## MODIFICATION

**Adding Protection circuit after changing the laser mechanism**

## SERVICE HINT

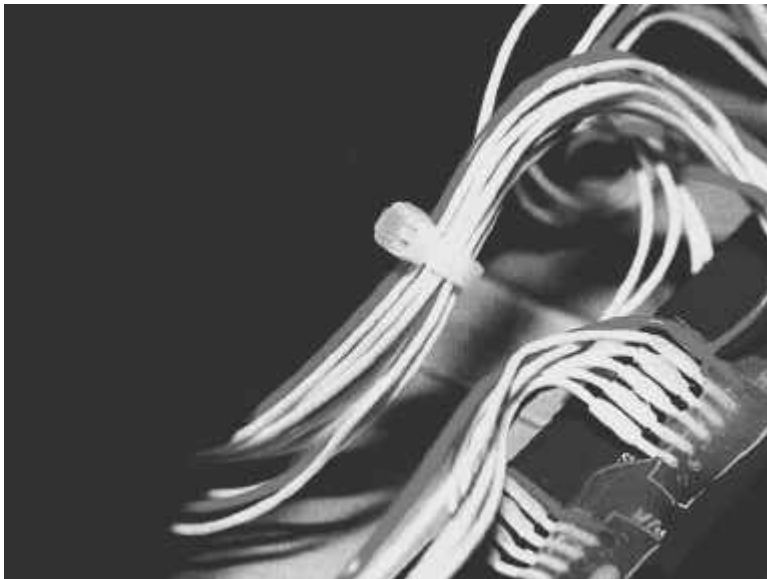
CD Player does not read disc, skips, produces scratching noise.

The cable tie that ties the two cables to the laser together scrapes over the bottom of the unit.

Relocate the cable tie as shown in the below picture, it's advisable to relocate the other cables as well to avoid any contact with the other cables.

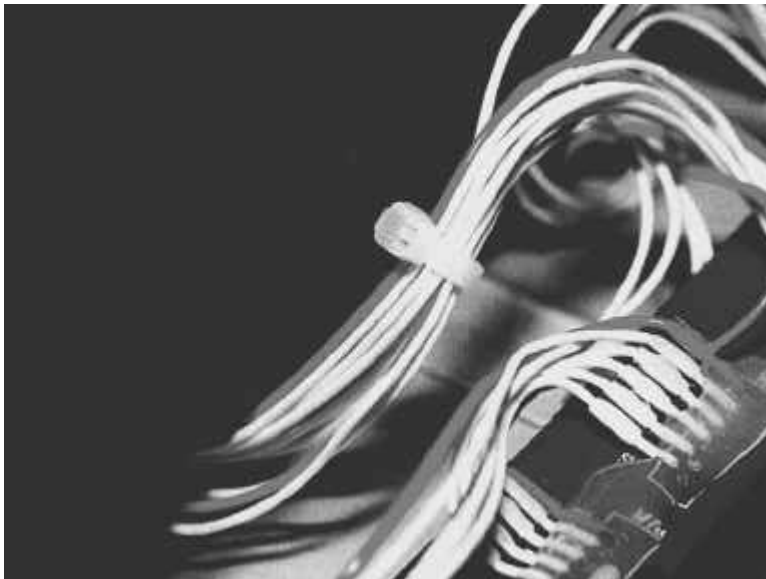
CD Player does not read disc, skips, produces scratching noise.

The cable tie that ties the two cables to the laser together scrapes over the bottom of the unit.

Relocate the cable tie as shown in the below picture, it's advisable to relocate the other cables as well to avoid any contact with the other cables.
